Planning and Development Services
Arun District Council
Arun Civic Centre
Maltravers Road
Littlehampton
West Sussex
BN17 5LF

Developer Services
Southern Water
Sparrowgrove House
Sparrowgrove
Otterbourne
Hampshire
SO21 2SW

Your Ref
WA/52/17/HH
Our Ref
PLAN-019530
Date
05/09/2017

Proposal: Two storey side extension & front porch.
Site: Wealden House, 7 London Road, Fontwell, BN18 0SG.
WA/52/17/HH

ARUN DISTRICT COUNCIL WA52/17/HH

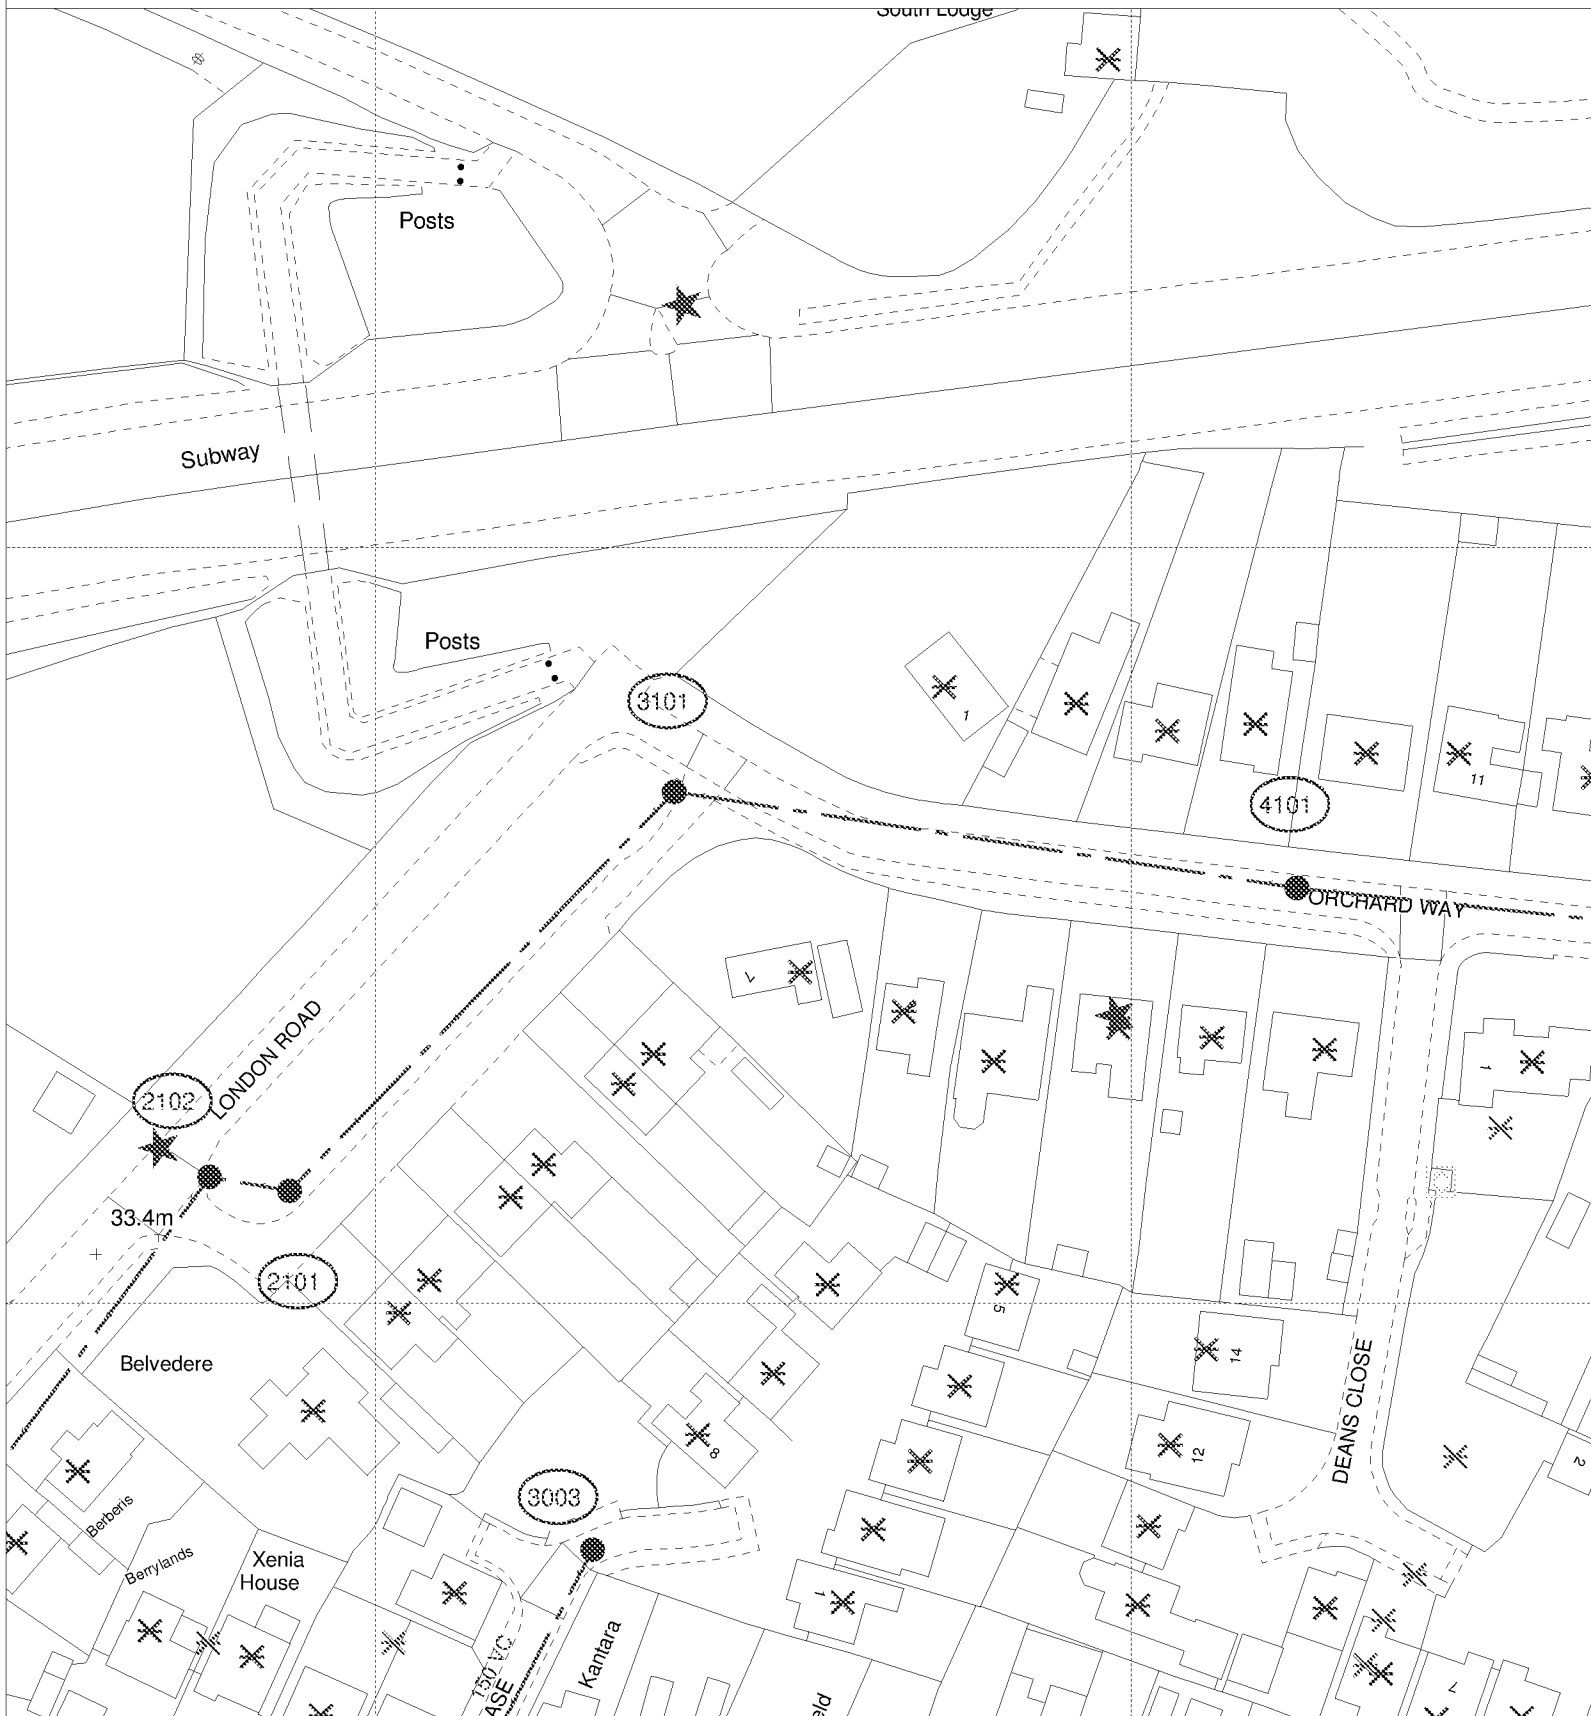
Our initial investigations indicate that there are no public surface water sewers in the area to serve this development. Alternative means of draining surface water from this development are required. This should not involve disposal to a public foul sewer.

The proposed development would lie within a Source Protection Zone as defined under the Environment Agency's Groundwater Protection Policy. The Environment Agency should be consulted to ensure the protection of the water supply source.

Due to changes in legislation that came in to force on 1st October 2011 regarding the future ownership of sewers it is possible that a sewer now deemed to be public could be crossing the above property. Therefore, should any sewer be found during construction works, an investigation of the sewer will be required to ascertain its condition, the number of properties served, and potential means of access before any further works commence on site.
